2012 International Swimming Pool and Spa Code Errata

1st PRINTING (October 3, 2012)

FIGURE 322.2
MINIMUM DIVING WATER ENVELOPE

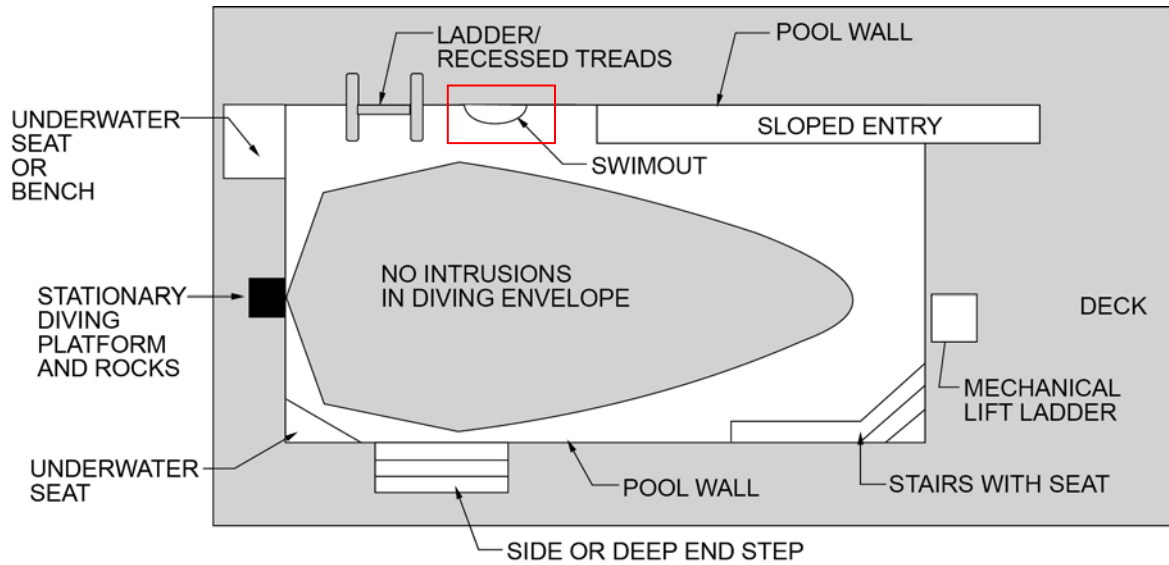
FIGURE 322.2
